**Subject: Cutler Hydroelectric Project (FERC Project No. 2420)  
Filing of Response to Bridgerland Audubon Society Updated Study Report  
Comment**

Bridgerland Audubon Society's comments on  
PacifiCorp's Cutler Hydroelectric Project  
(FERC Project 2420) Filing of Updated Study  
Report Meeting Summary, Sept. 15, 2021

Bridgerland Audubon’s responses to the Updated Study Report meeting (Sept. 15, 2021) with reference to the Initial Study Report Response to Comments, Cutler Hydroelectric Project (FERC No. 2420), Attachment 1, Initial Study Report Comment Response Table, May 5, 2021.

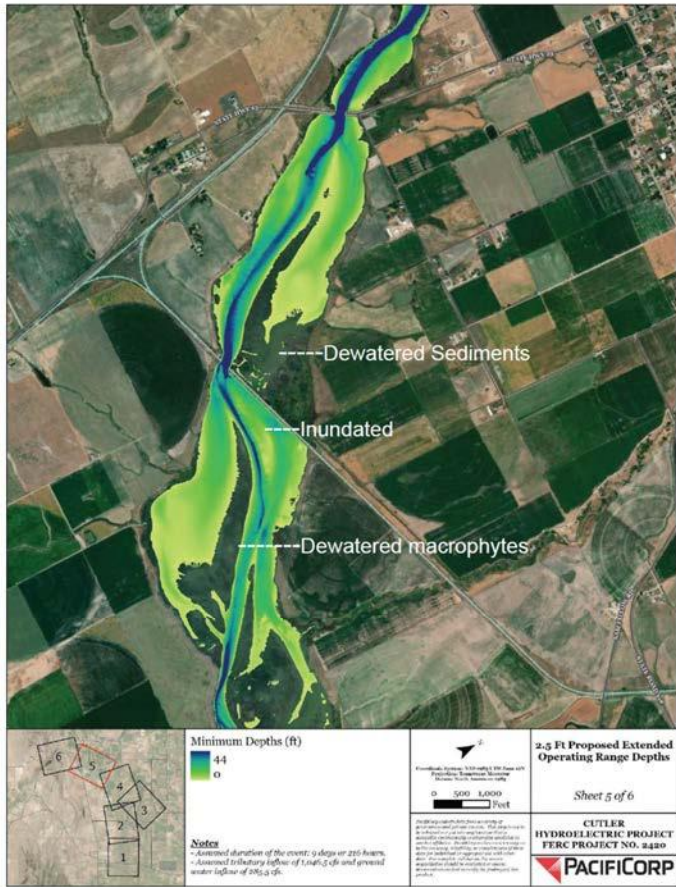
In your responses in the Response to Comments and subsequent presentation you indicate that drawdowns will not affect the benthic invertebrates because "*almost all of the reservoir bed remains inundated under conditions representative of the proposed extended operations lower limit at water surface elevation (WSE) 4,405.0 feet.*", and you presented aerial photographs of launch areas that do show limited exposure of sediments during the drawdown, although they do reveal that the emergent macrophytes (bullrush and cattails) are exposed. However, these boat launch areas are located in deep areas not representative of reservoir as a whole. If other areas are examined, appreciable portions of the sediments and emergent macrophytes will be exposed if a 2.5±0.5 ft. total drawdown is authorized. For example, analysis of your reservoir elevation modeling results for an area north of Benson Marina (Figure ISR-1-6, Sheet 5; Inundation boundaries for proposed normal, proposed extended and normal maximum pool elevations) indicates that 28% of this area would be exposed with a 2.5-foot drawdown.

Notably, all of the emergent macrophytes (13% of the area) would be exposed, as would the invertebrates residing in them. An even greater portion of the sediments would be exposed if the reservoir were drawn down to 4,404.5 ft. within PacifiCorp's requested tolerance range. Rather than aerial photographs of limited areas, a complete analysis of expected exposure of sediments during drawdown to 4405.0' and 4404.5' of all areas needs to be completed.

Figure 3. Shoreward location of depth measurements shown in Table 1.

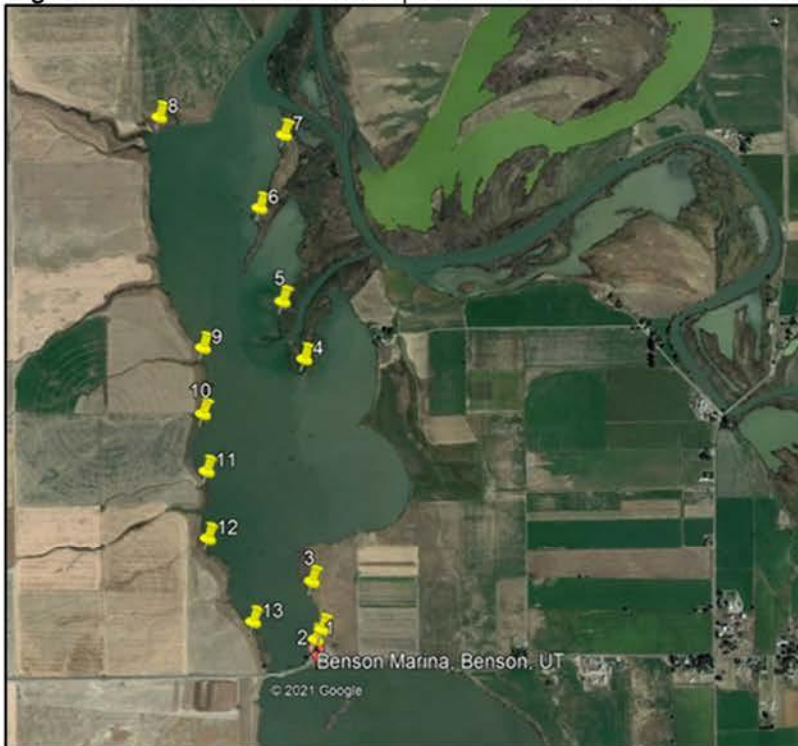
Site	Location	Depth at edge of emergents (feet)	Distance from shore to reach a depth of 2 feet
1	9 yds S of Benson launch ramp	0.25	24
2	21 yds N of Benson launch ramp	1.20	27
3	250 yds N of Benson launch	1.25	24
	<b>MEAN</b>	<b>0.90</b>	<b>25</b>
4	NE side	0.50	264
5	NE Side	0.92	159
6	NE Side	1.50	135
7	NE side	1.42	48
8	NW side	0.00	51
9	NW side	0.50	38
10	NW side	0.50	38
11	NW side	0.42	43
12	NW side	1.00	90
13	NW side	0.08	36
	<b>MEAN</b>	<b>0.68</b>	<b>90</b>

Table 1. Depth measurements at Benson Marina and northward 1.5 miles on the east and west side of the reservoir. 9-Oct-2021, 11:30-15:00 hrs. See Figure 3.
